**ECLIPSE**  
**Engineering Bulletin**  
No: EB-0405

**Product : Eclipse Exciter**

**Topic : Substrate Crack found in Mitsubishi RF Power modules**

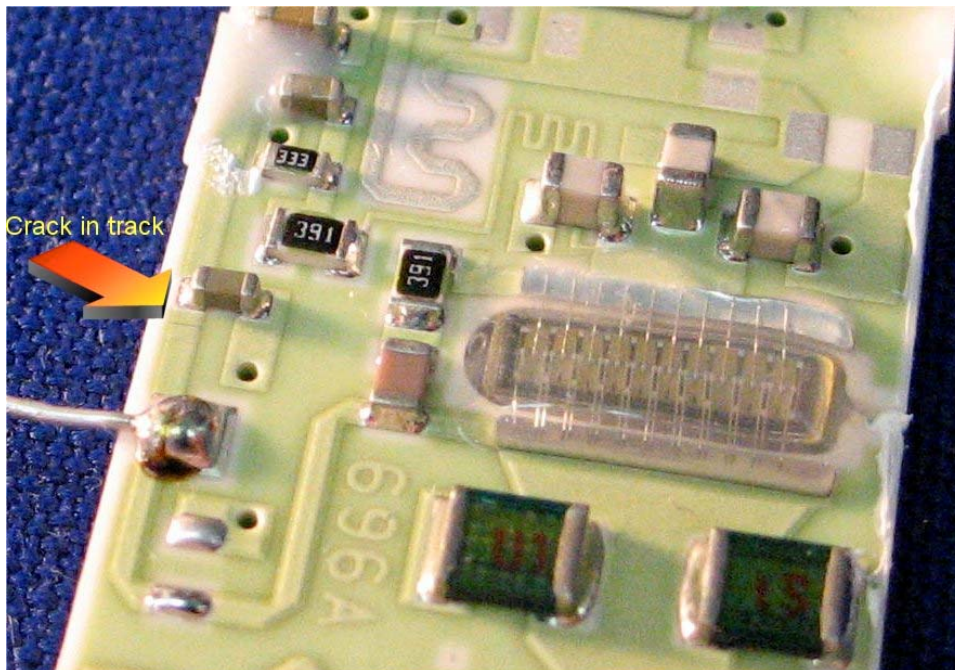
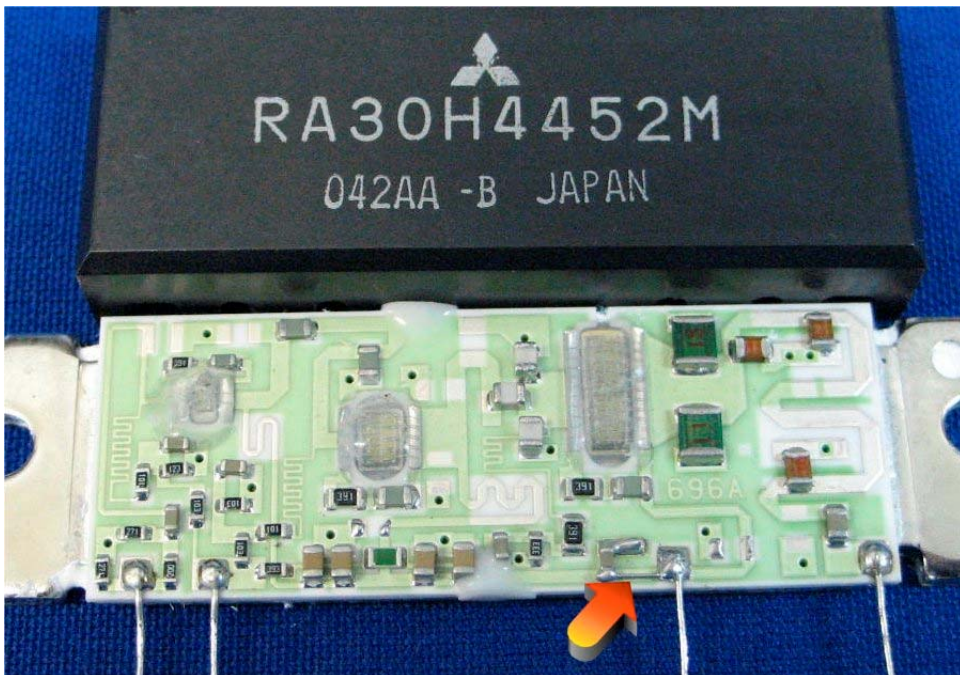
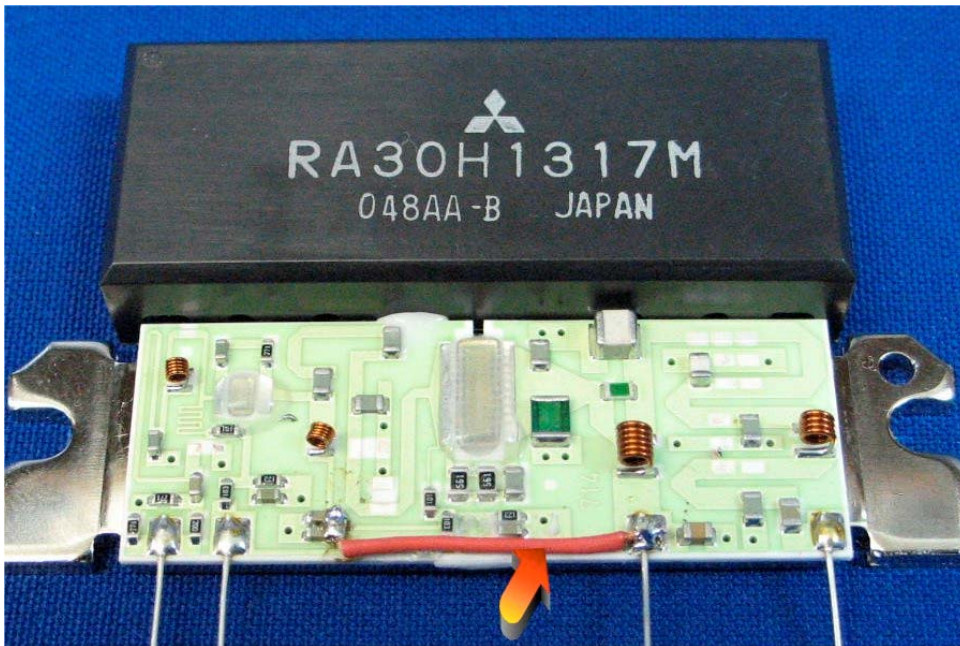
There have been recent reports of some faulty Mitsubishi modules in the field. The symptom is the exciter has no output power. The power supply track was broken inside the Mitsubishi RF power module due to the substrate cracked under some rapid temperature-changing situation.

This fault can occur in two types of Mitsubishi RF power modules:

VHF: RA30H1317

UHF: RA30H4452

If you find any faulty exciter of this symptom, please contact RF Technology for power module replacement. We currently fix this problem by connecting an additional wire to ensure the crack will not affect normal operation of the module.
